CONDUIT PLAN

CONTRACT CHANGE ORDER NO. 42
 SHEET X OF XX

SAS SUPERSTRUCTURE ROADWAY WESTBOUND LIGHTING AND ELECTRICAL SYSTEMS

E-50

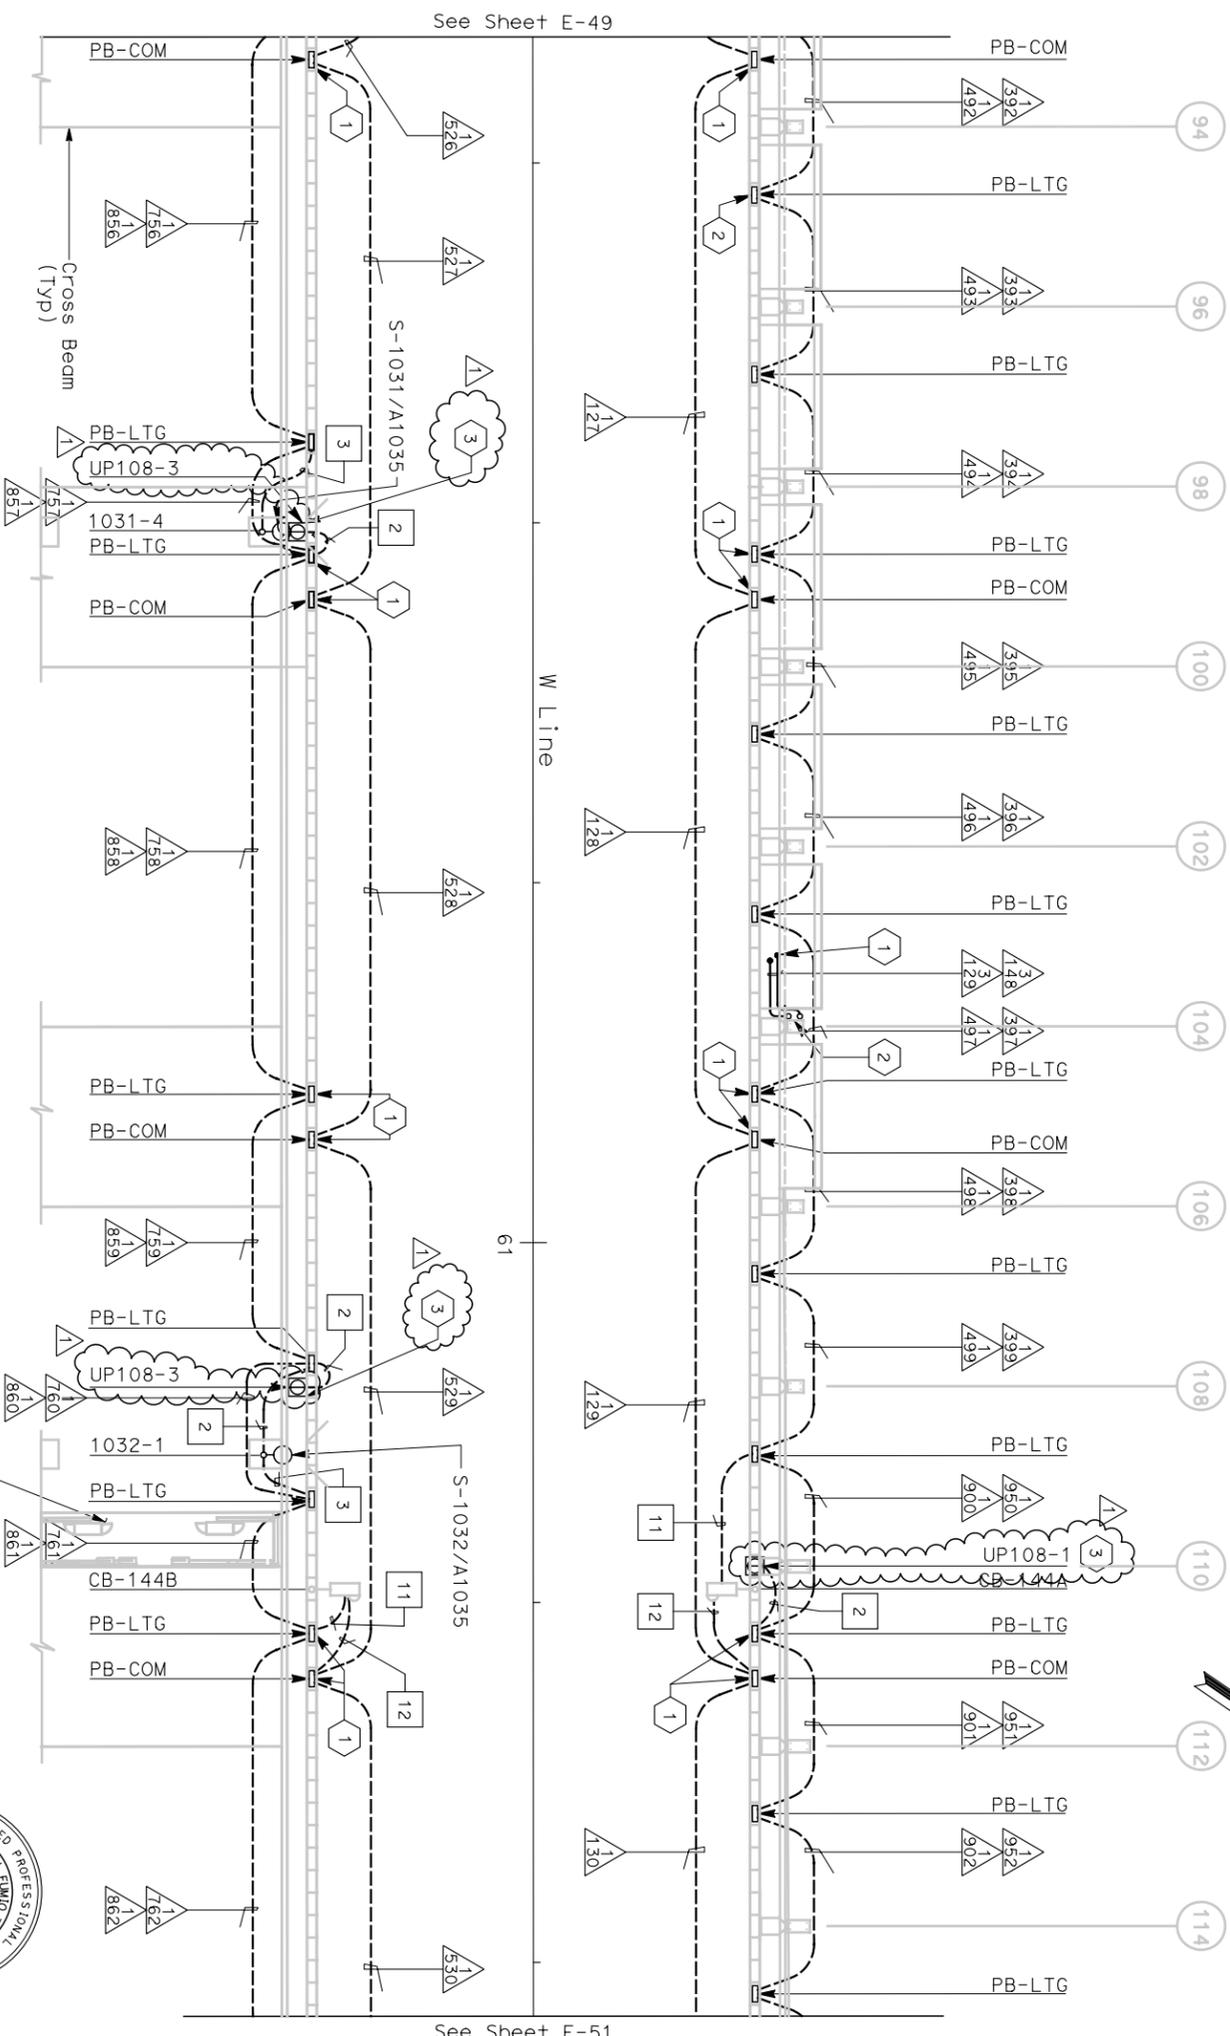
| MARK | DATE | REVISIONS | MP | EL | RR | 42 |
|------|---------|--|----|----|-----|----|
| Δ | 8-06-07 | Revision to misc. electric work. Change roadway barrier receptacle type per RFI-242. | | | | |
